Office Action Summary

10/753,388

DETAILED ACTION

FIG. 23

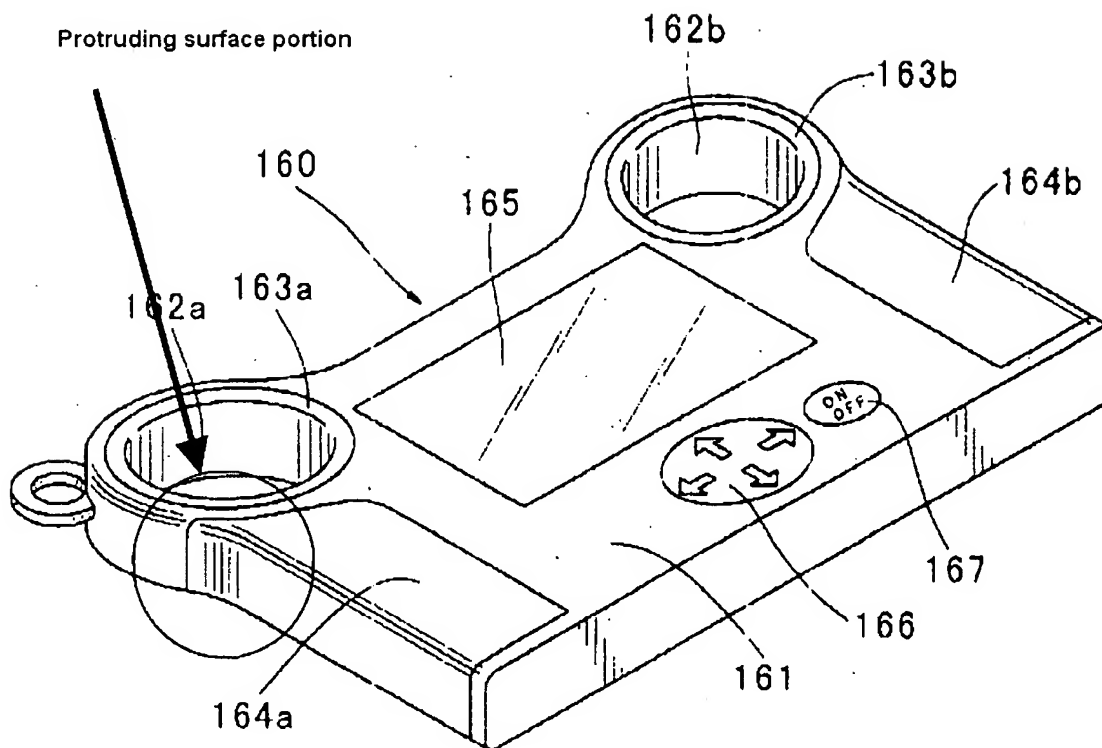
5. In regards to claims 1 and 13, Yamada discloses a handheld pulse measuring device (col. 23, line 18) comprising a shell having a top and bottom surface, shaped like a cube, and having an operating panel (Fig. 23). Further, Yamada discloses two gelless electrodes (164a and 164b) extending along the upper surface and passing over the edge to the bottom surface having a protruding surface portion to form a surface capable of being grasped by the root area between a user's fingers; an information display (165); and a calculation system (Fig. 5) for displaying electrical information. Please note that Yamada's invention is capable of meeting the electrode's functional recitation of "for detecting electrocardiogram signals" because an electrode senses any electrical signal that impinges on the electrode and no limitation is placed on actual analysis or display of the ECG signal.

6. In regards to claim 2 and 14, the operating panel has at least one button (166 and 167).

7. In regards to claim 22, the device further comprises two second electrodes fixed in the bottom surface (163a and 163b; not how the "rims" are exposed to the surface normal to the axis of the holes, satisfying the "fixed in the bottom surface" limitation).
